REVISION "G"

G 2-28-07	CHANGE E/P TO EXCLUSIVE LEFT TURN ON MD 22 APPROACHES SIGNAL SHOP FORCES
JWA	
F 2-12-02	ASBUILT FOR RED LIGHT CAMERA INSTALLATION
RRZ	
E	RED LIGHT CAMERA WB MD 22

MD 22 AND MD 132A/BEARDS HILL ROAD

TRAFFIC SIGNAL PLAN

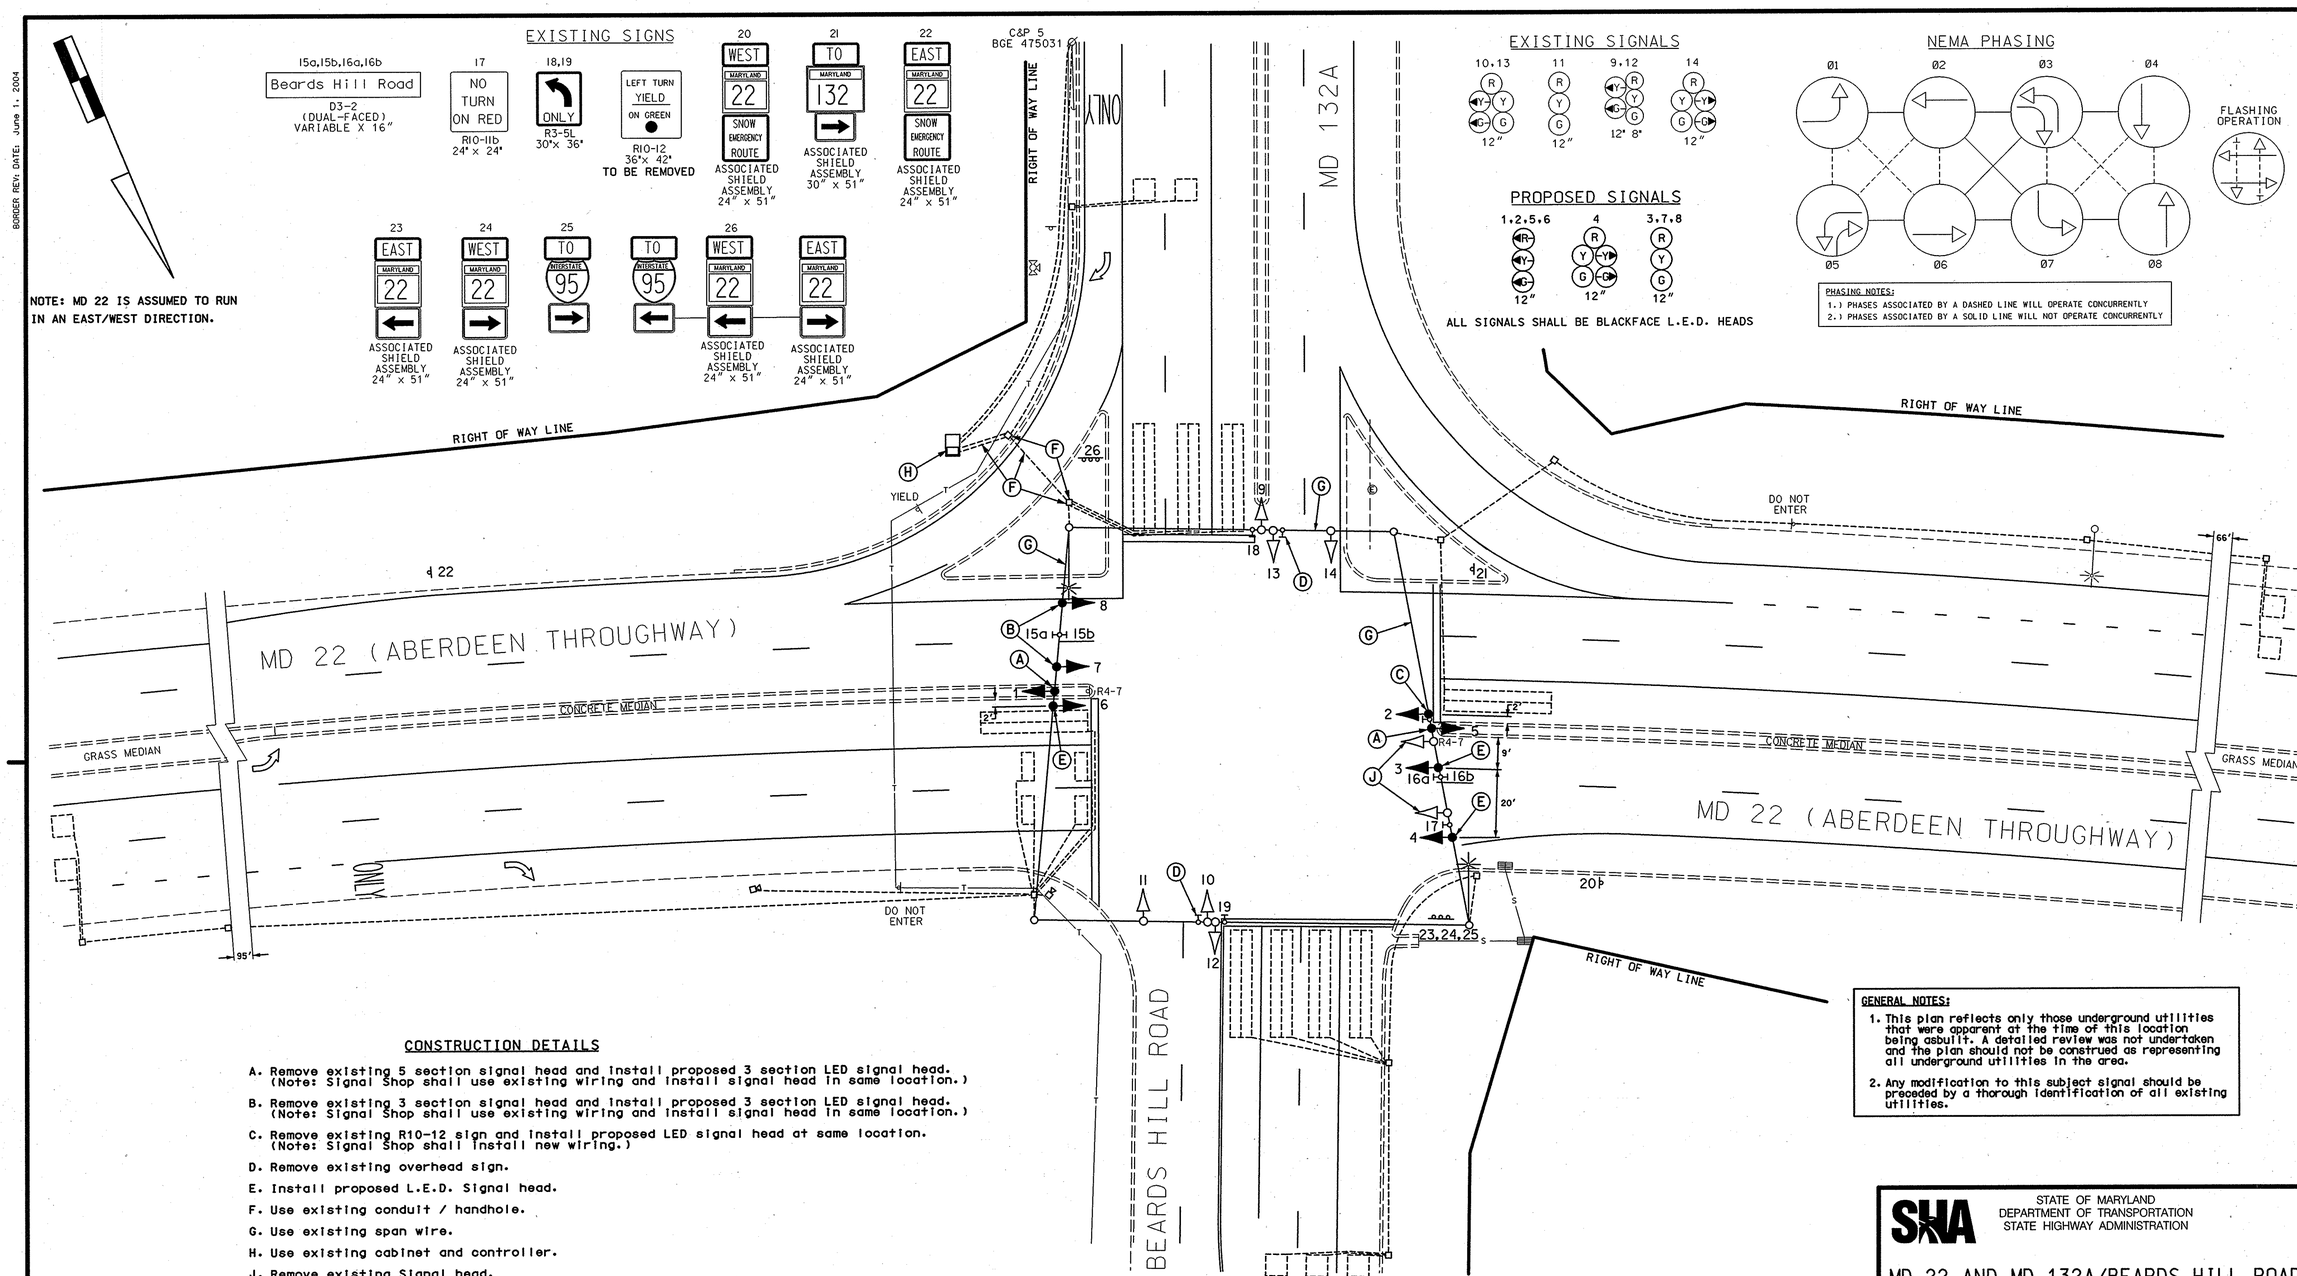
A. Remove existing 5 section signal head and install proposed 3 section LED signal head. (Note: Signal Shop shall use existing wiring and install signal head in same location.)

B. Remove existing 3 section signal head and install proposed 3 section LED signal head. (Note: Signal Shop shall use existing wiring and install signal head in same location.)

C. Remove existing R10-12 sign and install proposed LED signal head at same location. (Note: Signal Shop shall install new wiring.)

D. Remove existing overhead sign.

E. Install proposed L.E.D. Signal head.

J. Remove existing Signal head.
